Arlington Conservation Commission

Date: Thursday, October 1, 2020
Time: 7:30 PM
Location: Conducted by Remote Participation

Agenda

Attachment: Sheet L-4 Bioretention Basin and Swale Enlargement Plan.

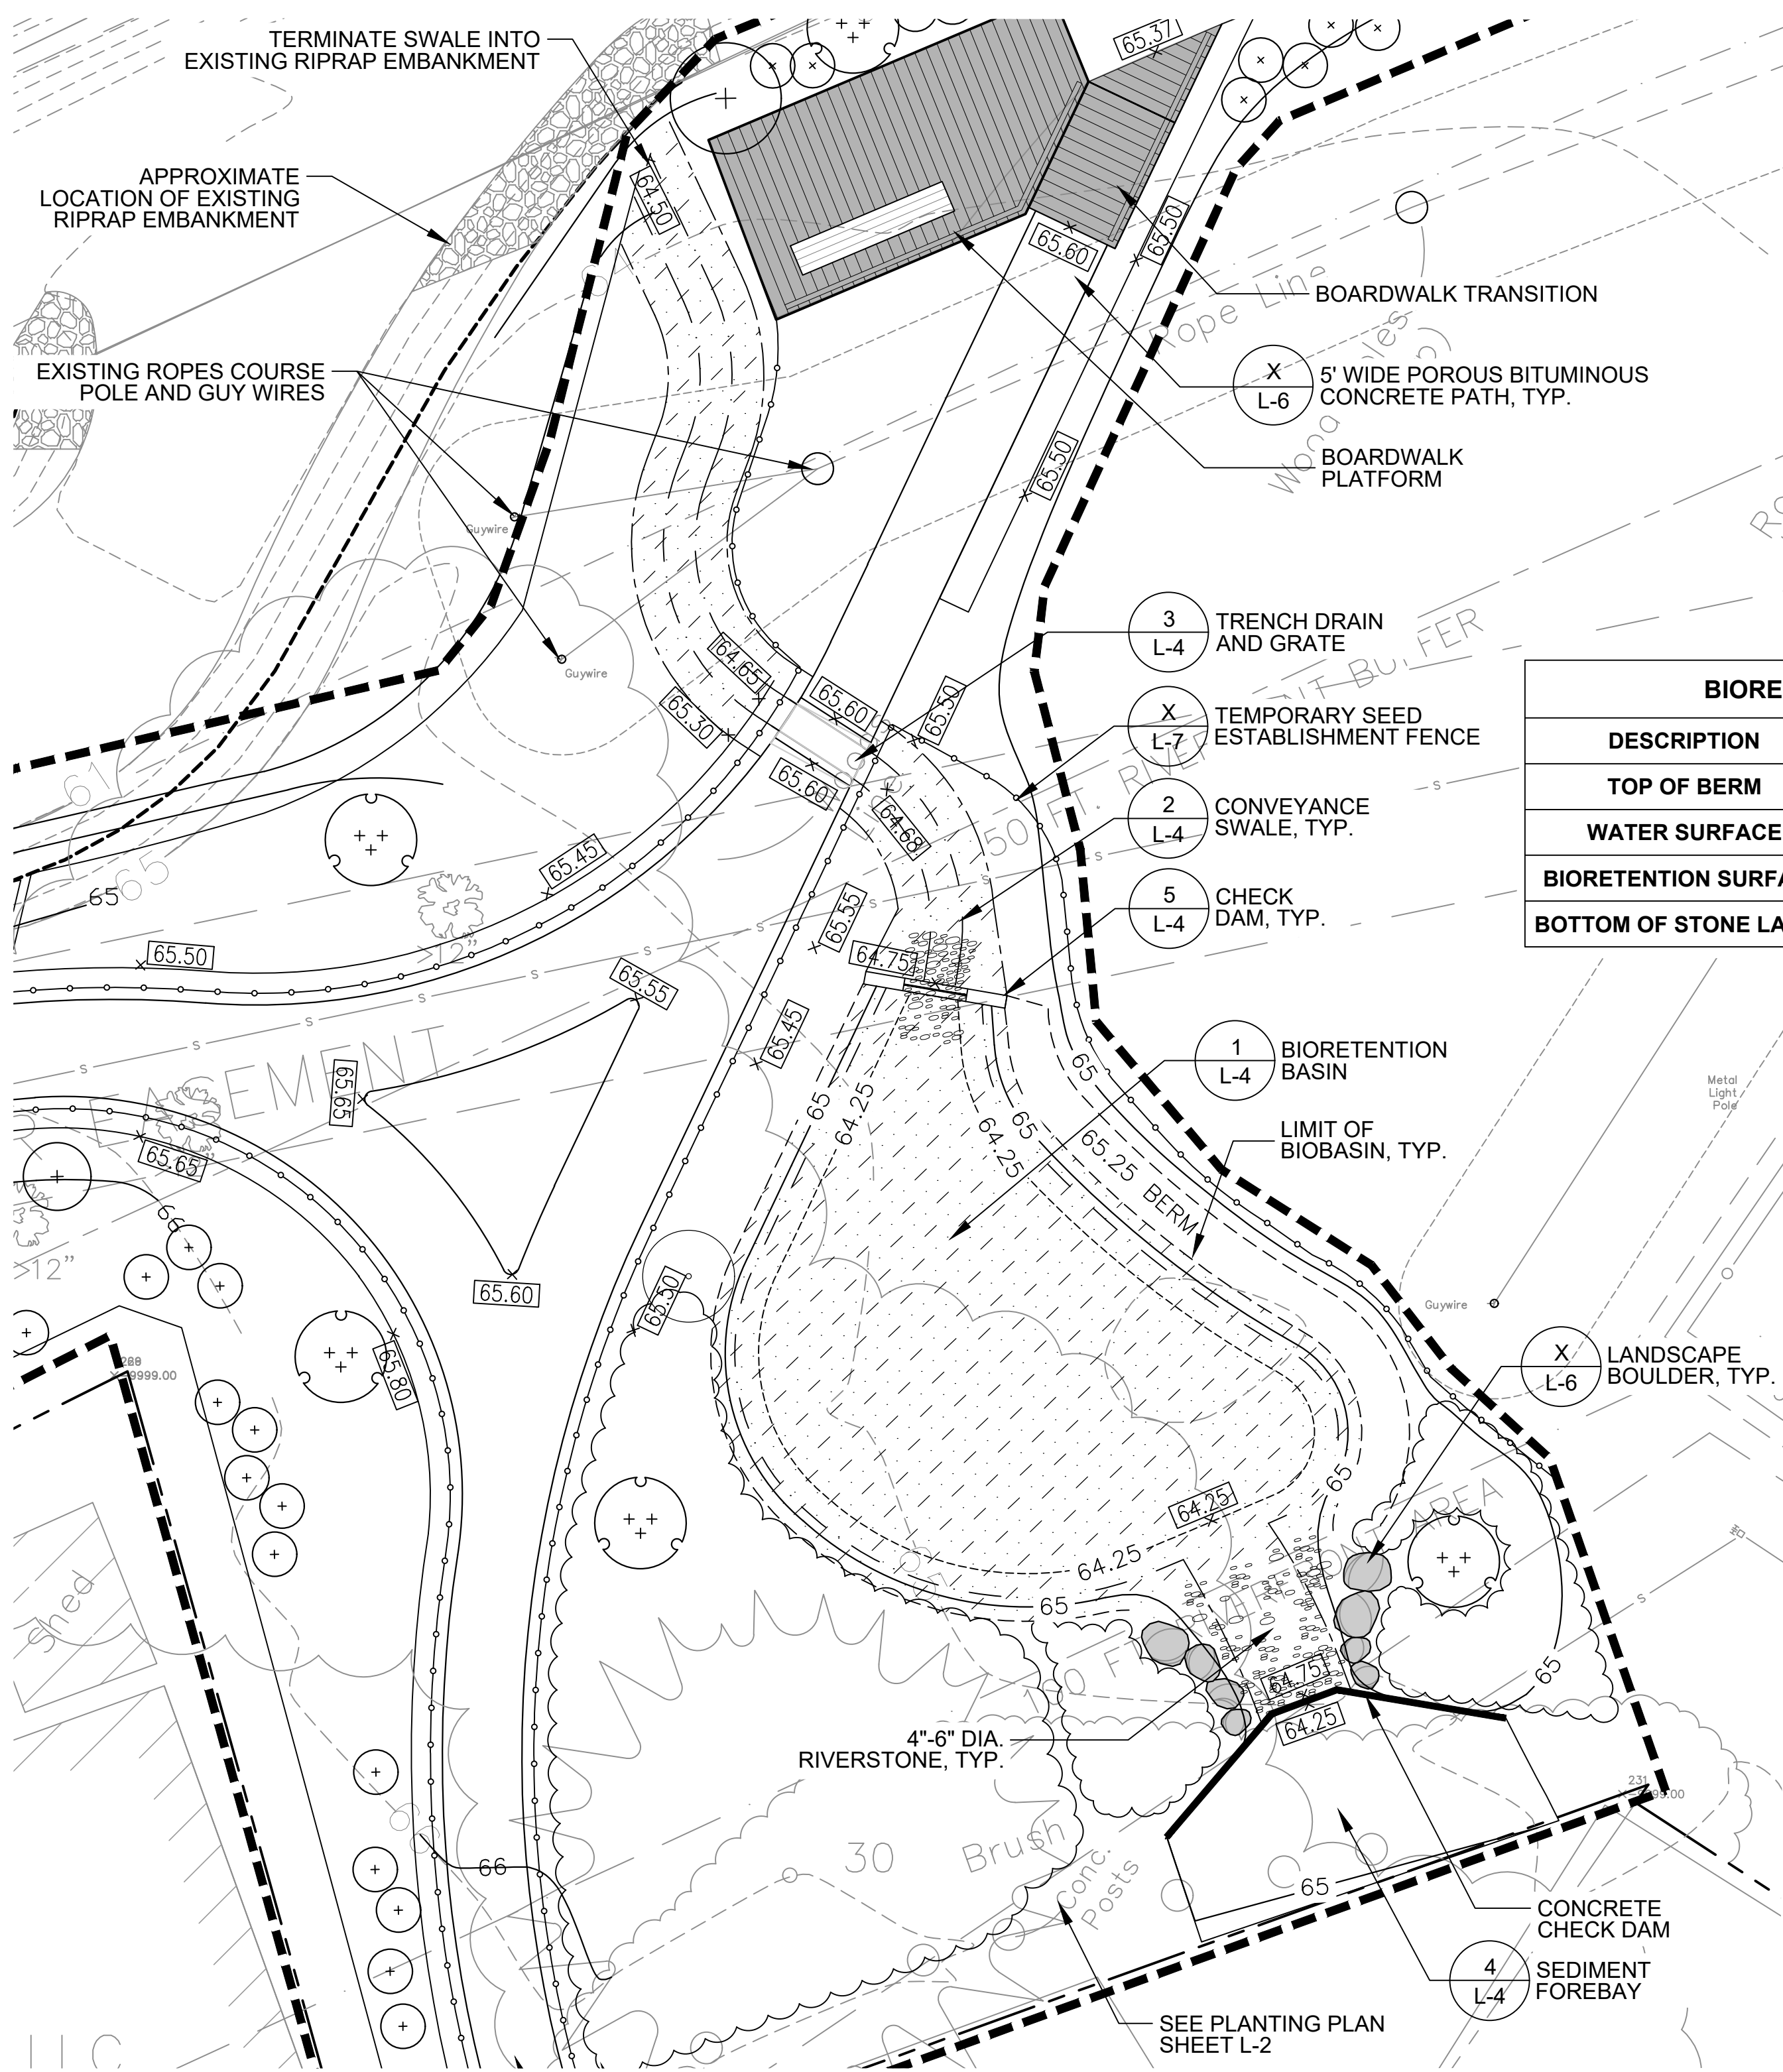
- 2.2.2 Who is "By Others"? Additional permitting/metering/etc. will be required by the DPW.
DPW would be responsible for installation of waterline and connection (cost exceeds project budget).

2.3 Standing Water in Bioretention Basin: any concern regarding mosquitoes (HHS)?
